INVITATION TO BID #2017-60
 SPRINGWATER ROAD AT CLACKAMAS RIVER BRIDGE
 ADDENDUM NUMBER 1
 August 17, 2017

Springwater Rd at Clackamas River Bridge - Bridge Approach Construction						
Spec No.	Item No.	ITEM DESCRIPTION	UNIT	AMOUNT	UNIT PRICE	TOTAL PRICE
MOBILIZATION AND TRAFFIC CONTROL						
0196	1	EXTRA WORK AS AUTHORIZED	FA	-	-	\$15,000.00
0210	2	MOBILIZATION	LS	ALL		
TRAFFIC CONTROL						
0225	3	TEMPORARY PROTECTION AND DIRECTION OF TRAFFIC	LS	1		
0225	4	TEMPORARY SIGNS	SQFT	230		
0225	5	STRIPE REMOVAL	FOOT	1200		
0225	6	PORTABLE CHANGEABLE MESSAGE SIGNS	EACH	3		
0225	7	FLAGGERS	HOUR	600		
0225	8	FLAGGERS STATION LIGHTING	EACH	3		
0225	9	TRAFFIC CONTROL SUPERVISOR	LS	1		
EROSION CONTROL						
0280	10	EROSION CONTROL	LS	1		
0280	11	MATTING, TYPE C	SQYD	100		
0280	12	CHECK DAM, TYPE 1	EACH	8		
0280	13	INLET PROTECTION, TYPE 3	EACH	7		
0280	14	SEDIMENT BARRIER, TYPE 8	FOOT	100		
0290	15	POLLUTION CONTROL PLAN	LS	1		
ROADWORK						
0305	16	CONSTRUCTION SURVEY WORK	LS	ALL		
0310	17	REMOVAL OF PIPES	FOOT	40		
0310	18	REMOVAL OF SURFACINGS	SQYD	1200

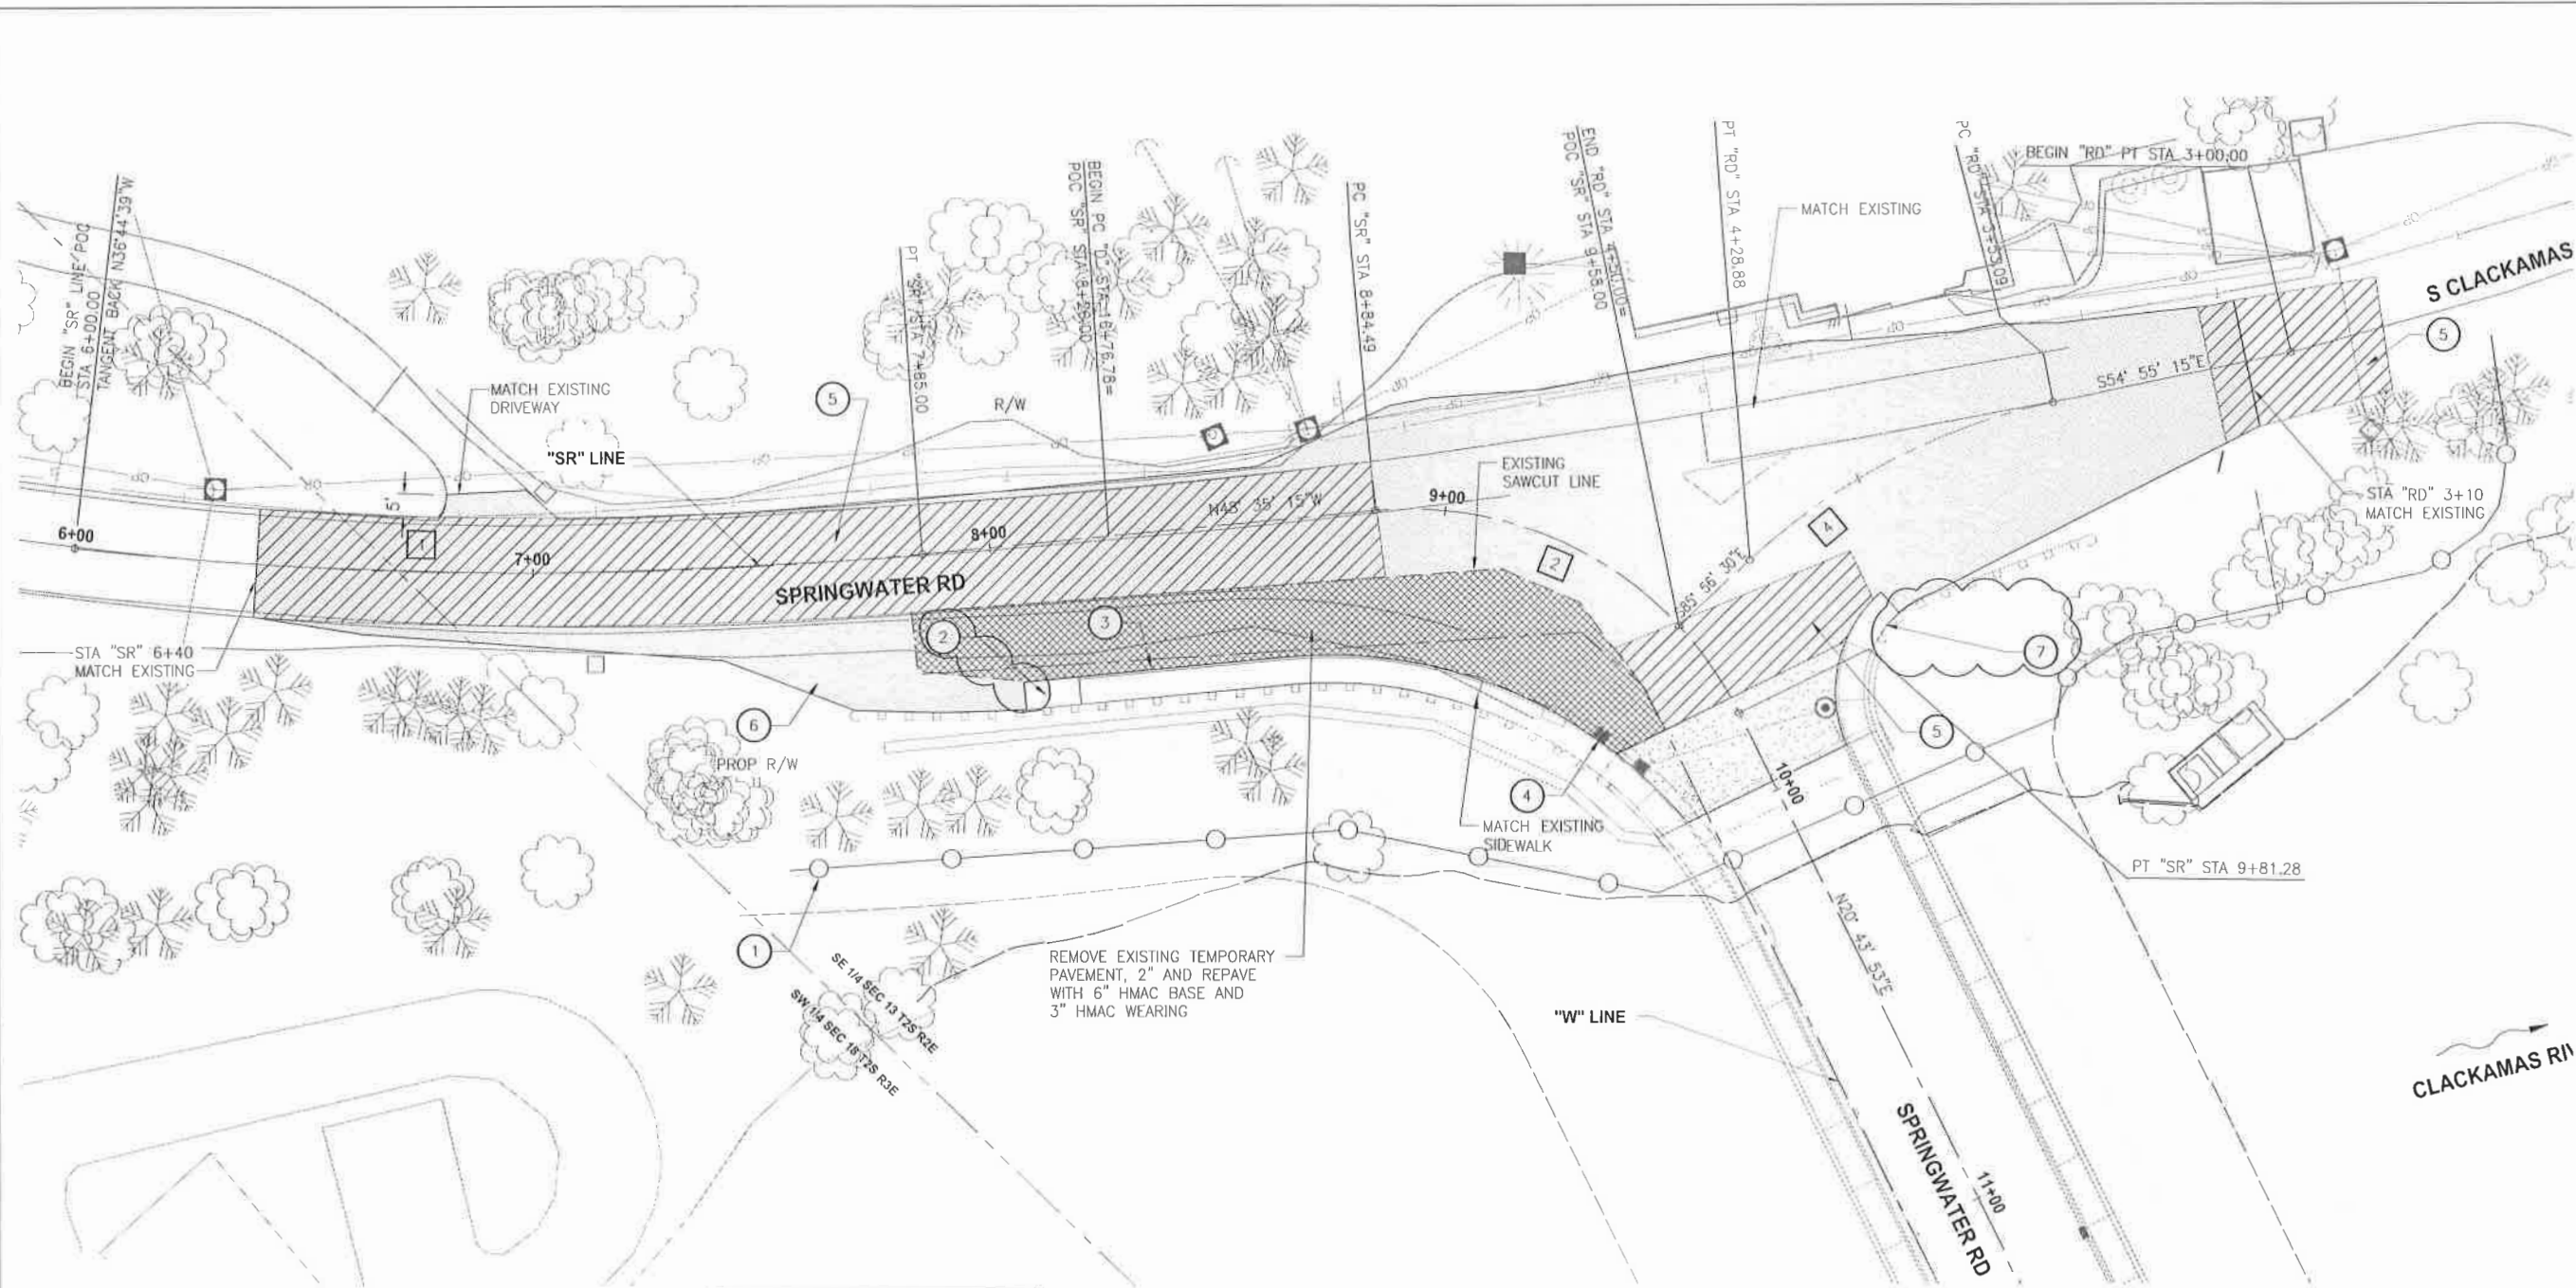
8. The following changes are made to the Project Plans:
Remove and replace Plan sheets No. 3 and 5 with the attached revised plan sheets title *Addendum #1 Sheet No. 3*, dated 8/17/2017 and *Addendum #1 Sheet No. 5*, dated 8/17/2017.

- CONSTRUCTION NOTES:**
- 1 REMOVE AND DISPOSE OF EXISTING SILT FENCE AND CONSTRUCTION FENCE
 - 2 CONSTRUCT SIDEWALK RAMP AND LANDING. (SEE DRG. NO. RD 756)
 - 3 STA "SR" 8+16.75 TO STA 9+20.00 RT
CONSTRUCT CONC. CURB - 89LF
CONSTRUCT CONCRETE WALK - 490SF
 - 4 REPLACE AND ADJUST TO GRADE EXISTING CATCH BASIN TOP/RIM
 - 5 0"-3" GRIND AS DIRECTED
 - 6 REMOVE AND DISPOSE OF EXCESS AGG/AC AS PART OF REMOVAL OF STRUCTURES (50CY±)
 - 7 RETROFIT EXISTING CONCRETE RAMP (SEE DRG. NO. RD 756)

Sheet No. 5

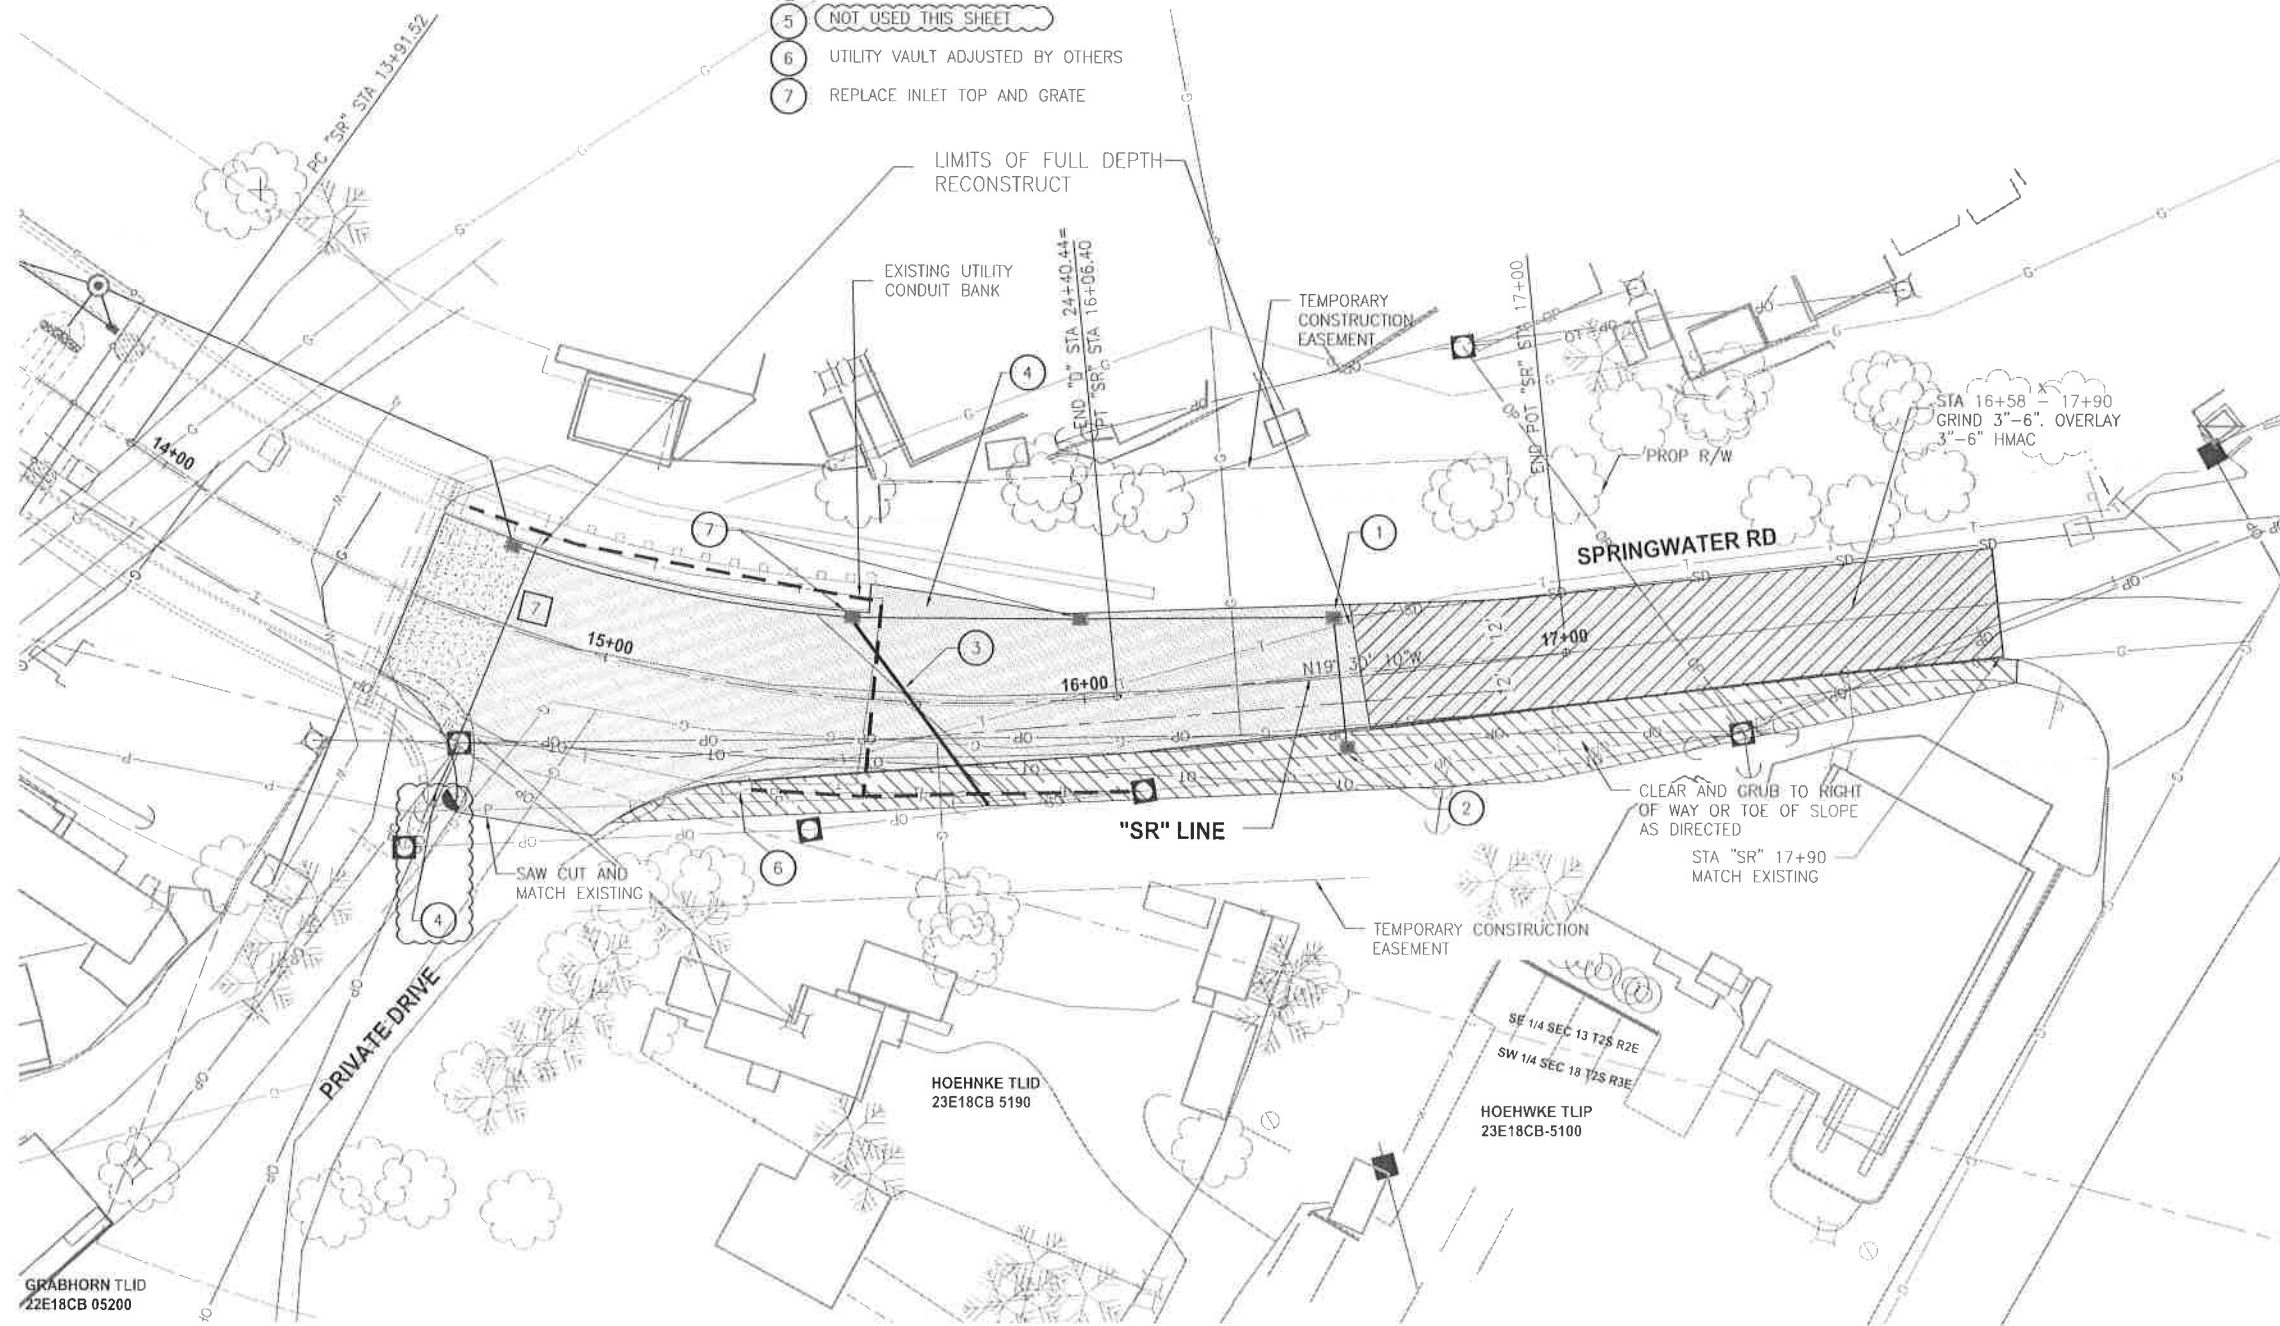
- ① STA "SR" 16+53, LT. EXISTING INLET TYPE GB-2 RIM=126.03 IE=122.11
- ② STA "SR" 16+53, RT. INSTALL INLET TYPE GB-2 (FIELD FIT TO DITCH) RIM=126.24 IE=122.35 INSTALL 12" STORMWATER PIPE -30LF
- ③ REMOVE EXISTING PIPE -40LF, CAP EXISTING "T"
- ④ CONSTRUCT HMAC SIDEWALK RAMP
- ⑤ NOT USED THIS SHEET
- ⑥ UTILITY VAULT ADJUSTED BY OTHERS
- ⑦ REPLACE INLET TOP AND GRATE
